The U.S. Fish and Wildlife Service (Service) is providing comments on the Mulqueeney Ranch Wind Repowering Project draft Subsequent Environmental Impact Report (SEIR). The mission of Service is to work with others to conserve, protect and enhance fish, wildlife, plants and their habitats for the continuing benefit of the American people. As part of our mission, we are charged with implementing various statutes, including the Bald and Golden Eagle Protection Act (16 U.S.C. 668-668d; Eagle Act) and the Migratory Bird Treaty Act (16 U.S.C. § 703 *et seq.*; MBTA). Our review and comments focus on our legal mandate and trust responsibility to maintain healthy bird populations for the benefit of the American public pursuant to the Eagle Act and MBTA. Our comments are consistent with Alameda County's (County) request that the Service provide technical assistance as a member of the Alameda County Altamont Pass Wind Resource Area (APWRA) Technical Assistance Committee (TAC), helping the County to address wind turbine impacts to eagles, birds, and bats.

The California Department of Fish and Wildlife (CDFW) received a Notice of Availability from the Alameda County Planning Department (County

Figure 19. Positions of 11 GPS-telemetered golden eagles in flight within 200 m of the ground in the west-central portion of the Mulqueeney Ranch wind project between 2013 and 2019.

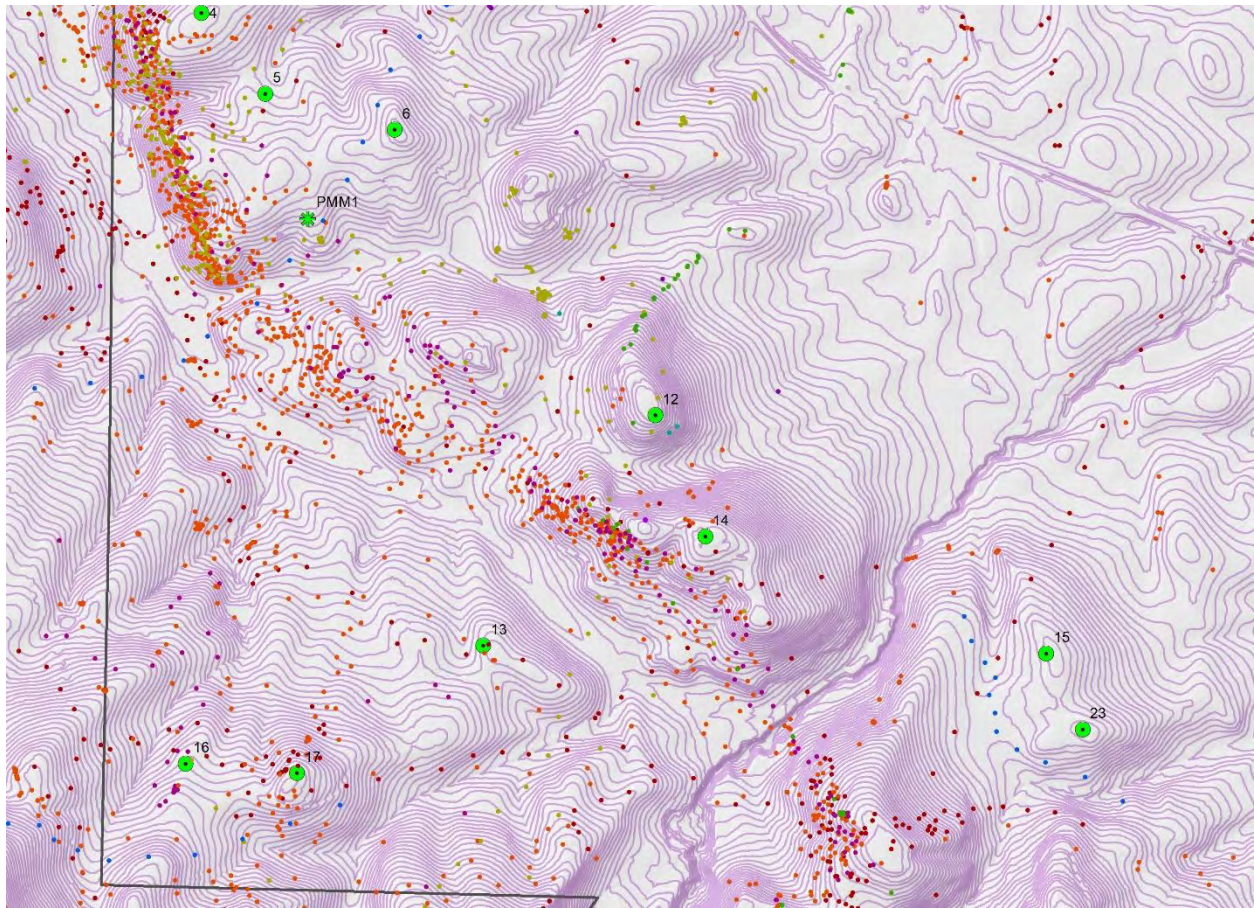
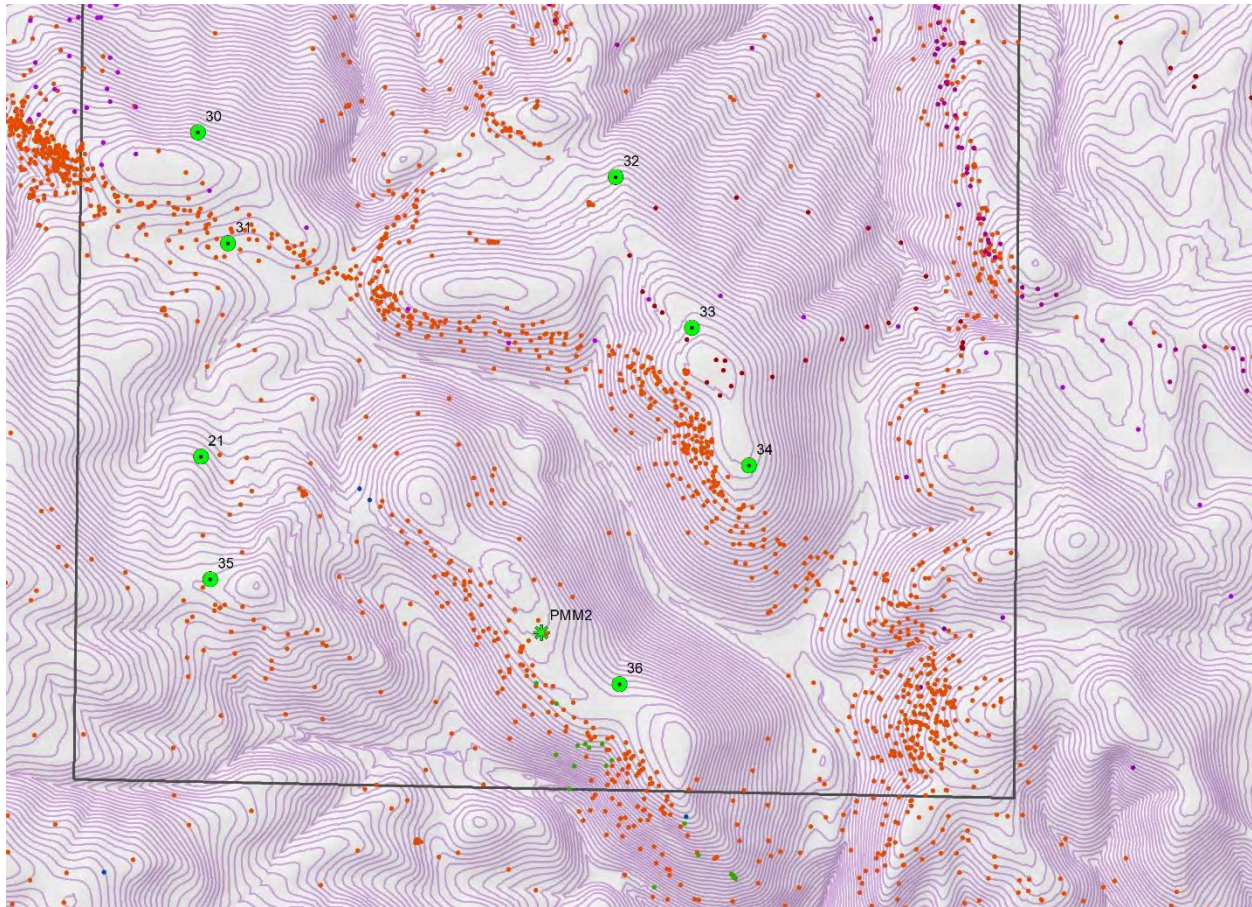
One of the most dangerous turbine sites proposed in the Mulqueeney Ranch project would be site 31 (Figures 20 and 22). Site 31 is located right in the middle of a golden eagle ‘river’ of flight activity. **Based on my experience with behavior surveys, the reason** for the intense activity there is obviously due to the declining ravine leading towards a prominent southwest face of a long ridge structure terminating to the east against the face of a north-south oriented ridge structure. The terrain setting is a perfect setup for golden eagles to build speed as they glide east down the ravine to the ridge-face where deflected updrafts provide free lift and outstanding flight control, finally banking into the eastern backstop. Installing a turbine at site 31 would essentially guarantee golden eagle collision fatalities. By the time golden eagles arrived at site 31, they would be traveling too fast to avoid passage through the rotor plane.

In addition to site 31, and for the reasons given in Table 7, I could not recommend turbines at sites 1 through 8, 14 through 17, 19-22, 24-39, 5C nor 17C. I could not recommend turbines at 34 (84%) of the 41 sites. A few other sites pose considerable collision risk to golden eagles, but those risks could be reduced by relatively small relocations of the turbines to avoid inherently hazardous terrain conditions or the creation of hazards from construction grading. An example would be site 18, which could be safer 80 m north. Overall, the layout of the project appears too dangerous for golden eagles, and will cause excessive mortality. The risk of the project to golden eagles could be reduced substantially by halving the installed capacity and more carefully siting the 18 or so turbines that remain in the project.

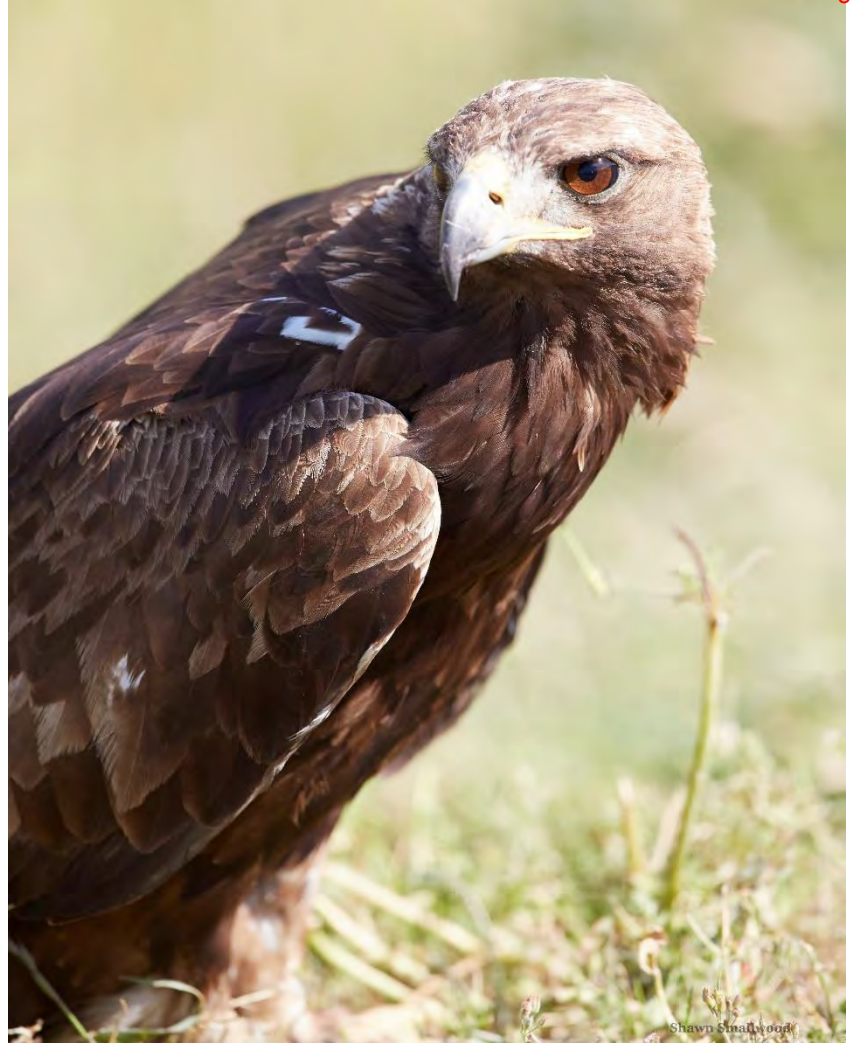
Of the 38 turbine sites occurring within areas to which Mr. Neher and I were able to extend our golden eagle collision hazard model, 18 (47%) were within Collision Hazard Class 4 – the most hazardous of the Classes predicted by our model. Fourteen (37%) of the sites were in our model-predicted Hazard Class 3. Because our policy was to recommend siting turbines outside Hazard Classes 3 and 4, we would have begun our assessment with concern over the proposed sites of 84% of the turbines in the project. We might have overlooked model predictions at some of the locations, based on site assessments and other circumstances, but we would have also recommended against a few of the sites in lower model-predicted Hazard Classes, such as the original site 31 and newest site 16.

Based solely on my SRC-style ratings, I would recommend against 26 (63%) of the **proposed sites after the relocations per Estep’s micro-siting assessment**. Considering likely grading effects that increase collision hazard, I would recommend against even **more sites**. **The layout, even after Estep’s micro-siting assessment**, would be unnecessarily dangerous to golden eagles. At least 50% of the sites should be removed from the project, and the remainder laid out more safely.
